ADDENDUM

PROJECT:	Family Partners 351-377 Forest Summit Court Manchester, Missouri 63021	ADDENDUM No.	1
OWNER:	Family Partners Manchester 351-377 Forest Summit Court Manchester, Missouri 63021	DATE OF ISSUANCE:	06-12-2019
CONTRACT FOR:	New Construction	ARCHITECT'S PROJECT No:	18036.00

3.5 Dimensions

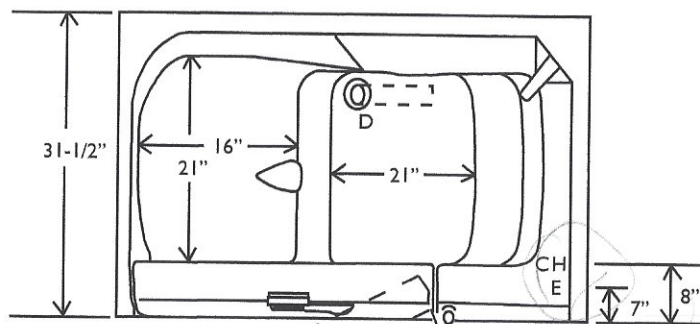
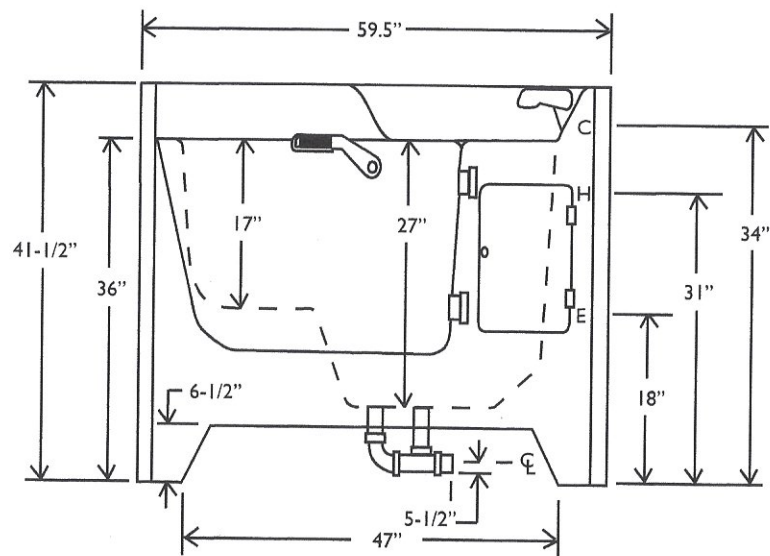
1. Medical Equipment Cut Sheets: Added Invacare Cut sheets (2 pages) identifying manufacturer installation dimensions and connections for Hot & cold water, electric and drain. See attached new cut sheets.

C	3/4" Cold water stub with recommended shut off valve
D	2" Drain (floor drain recommended)
E	115V AC, 60 Hz, 15 A Input
H	3/4" Hot water stub with recommended shut off valve
Allow for 40" door swing (60" for wheelchair or lift access)

E1

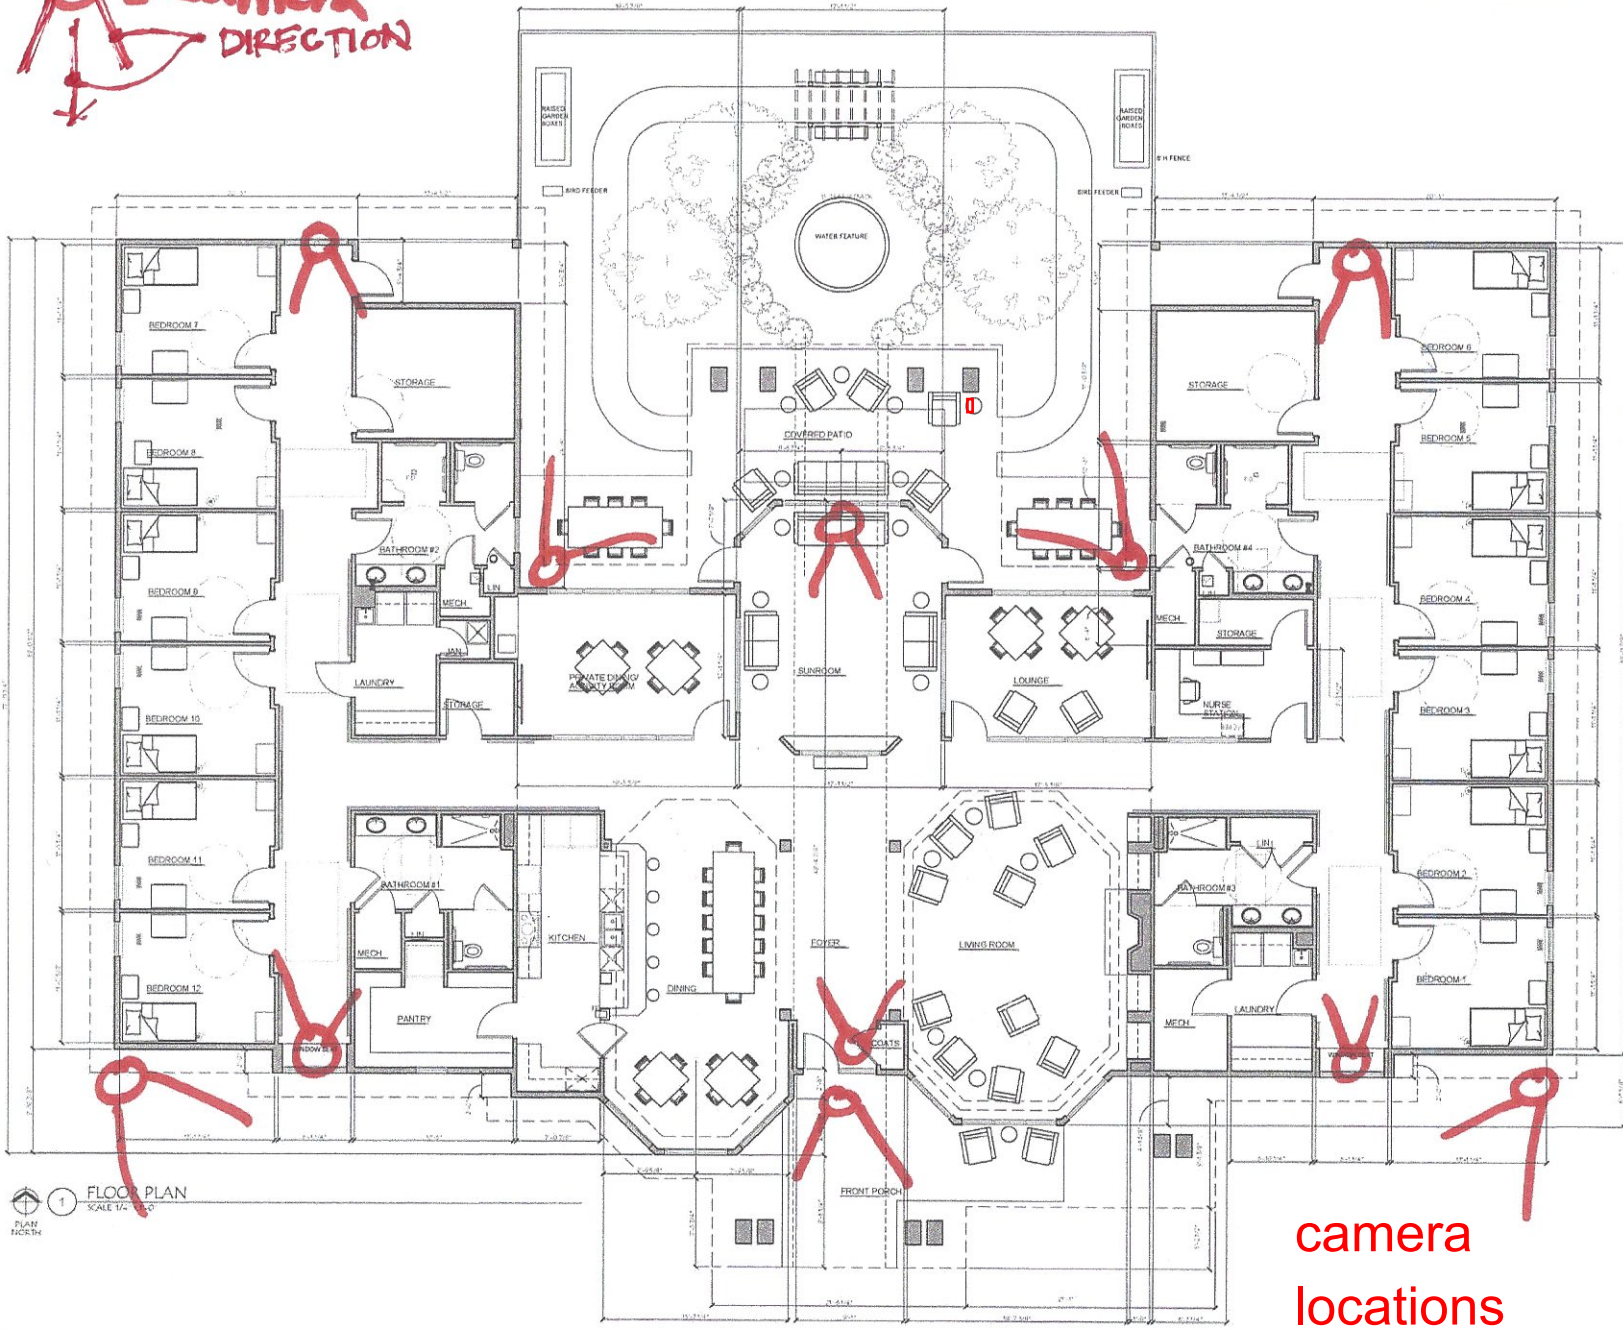
- b. Closers – LCN, 4000 series.
 - c. Exit Devices – Von Duprin, 33A/ 35A series.
6. Section 416000 Electrical System Design Criteria, page 8; add new plan drawing E1 referencing camera locations for the security system. See attached new sheet E1.

camera
locations
